Client:
The Herbert Family

Title:
PLANNING PROPOSALS
6 Manor Gardens Road
Hampton
Middlesex TW2 2TU
Home Tel 020 8979 5516

Number:
EH 2805/02

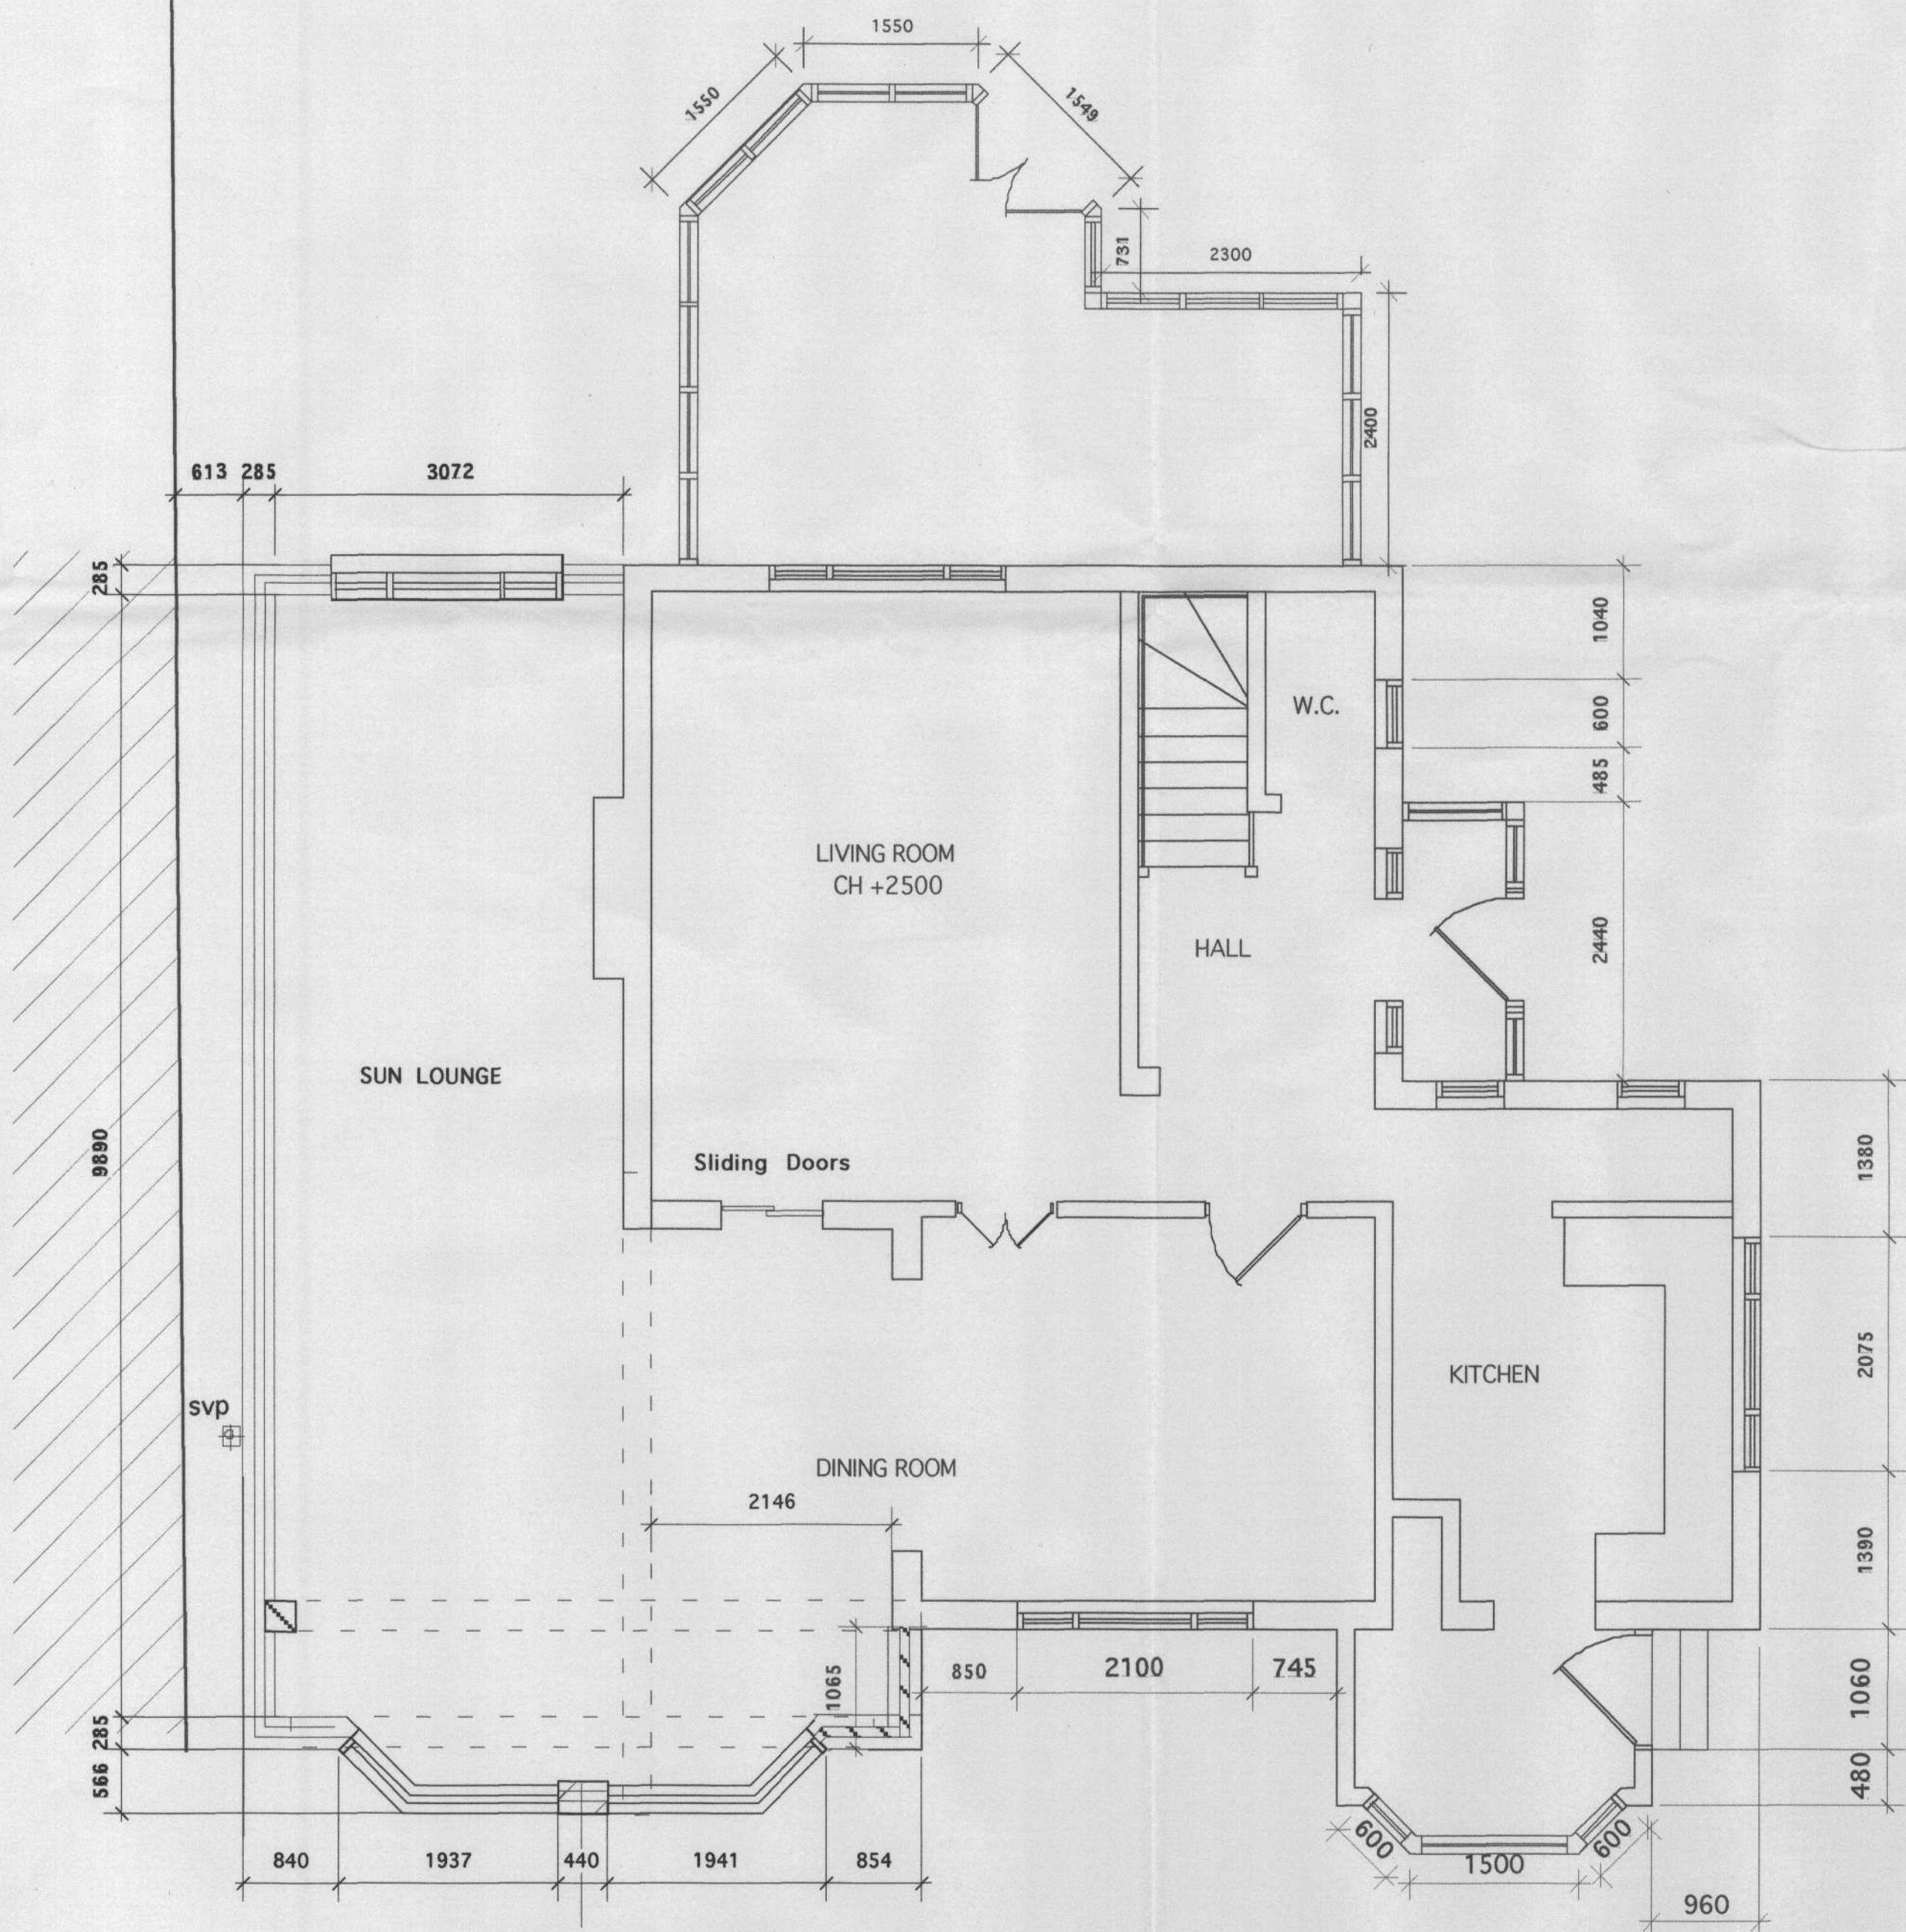
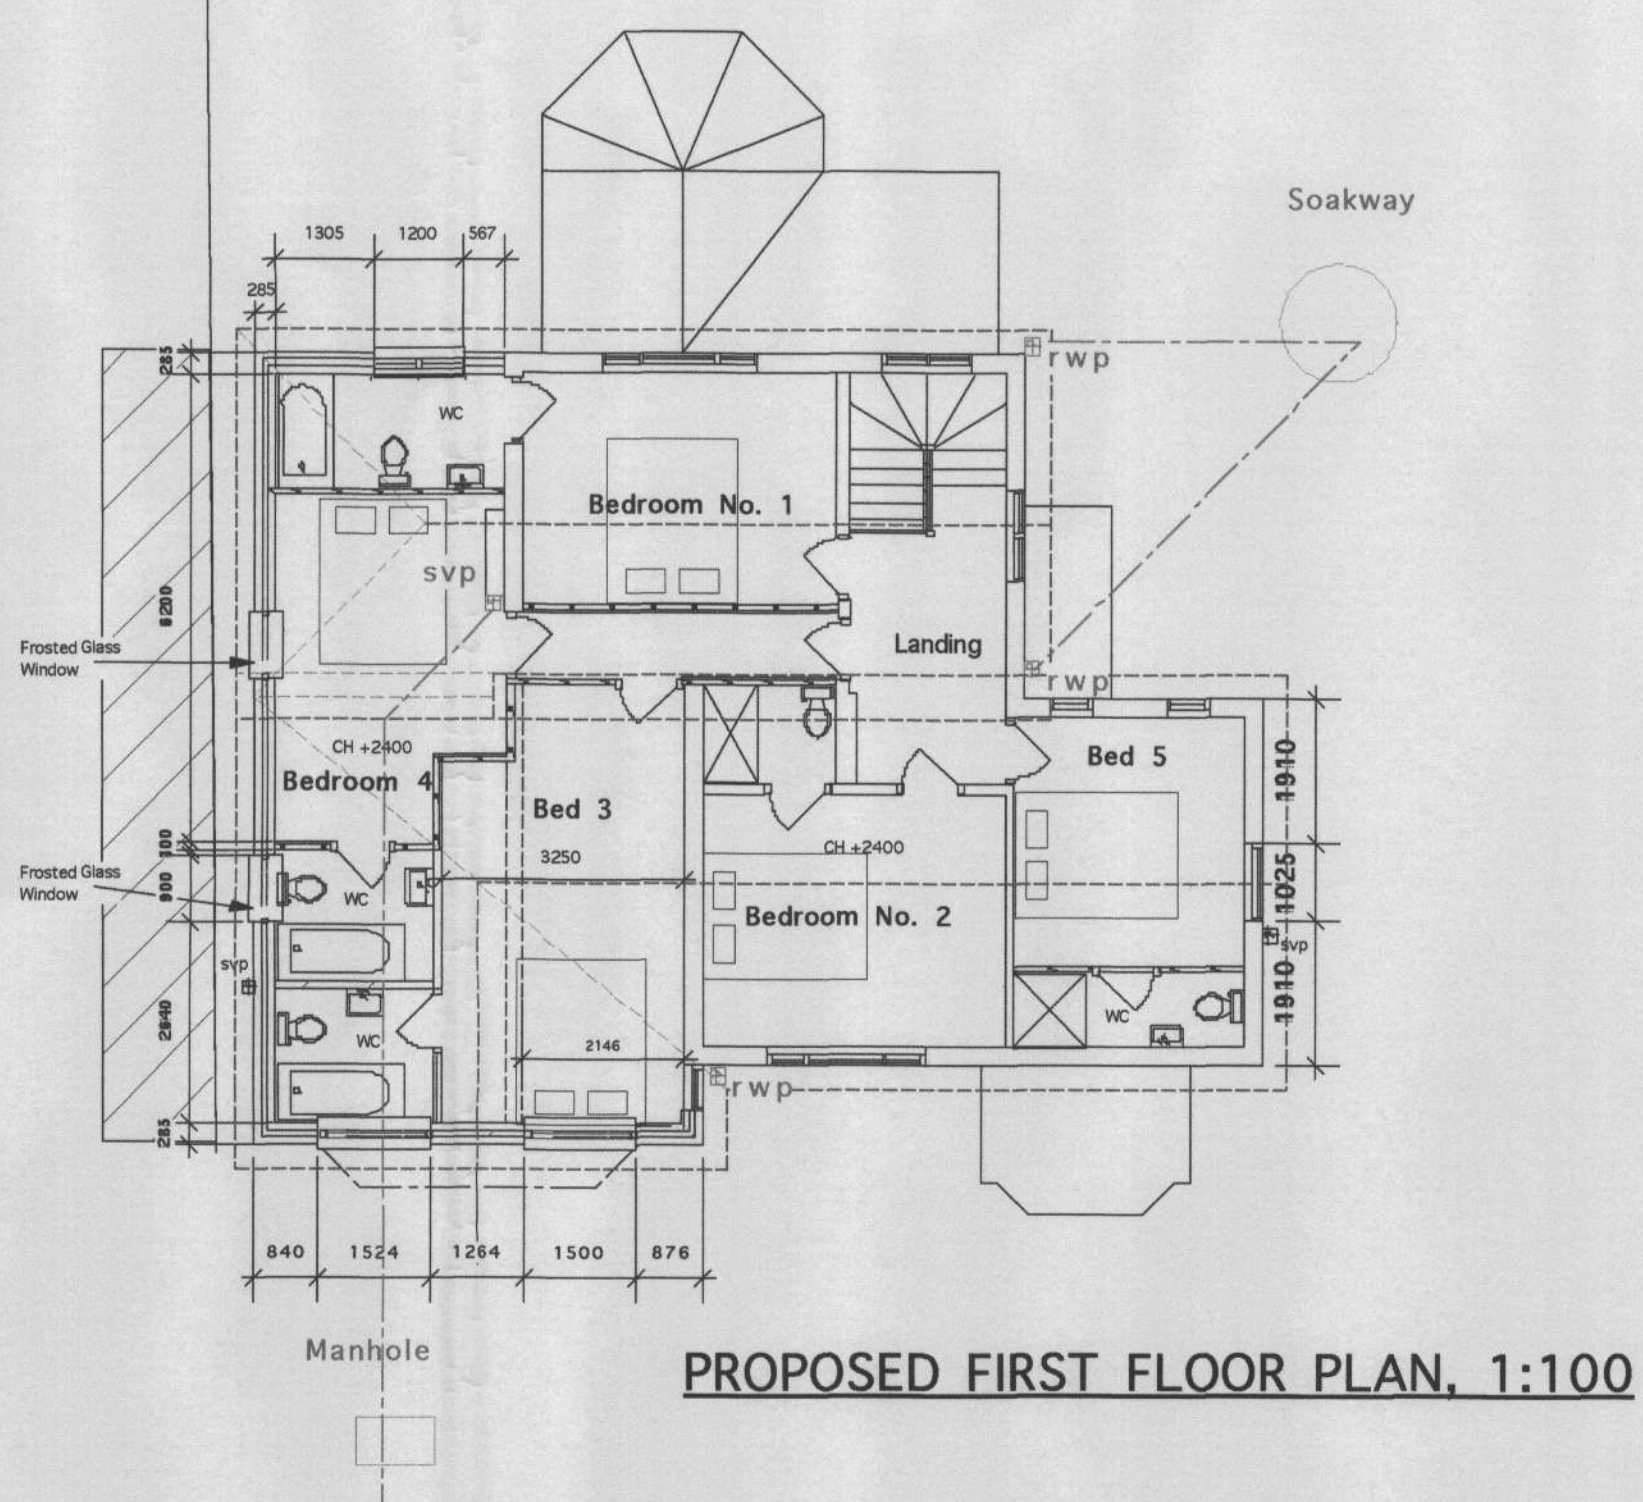
Rev B- 20/3/07, Bedroom 5 added to client request & approval to Pre-application, ensuite bathrooms added to all bedrooms

Rev A- 19/3/07 Bedroom 3 Wall Moved to client request & approval to Pre-application, end gable revised to Hip roof to suit LBRUT's comments.
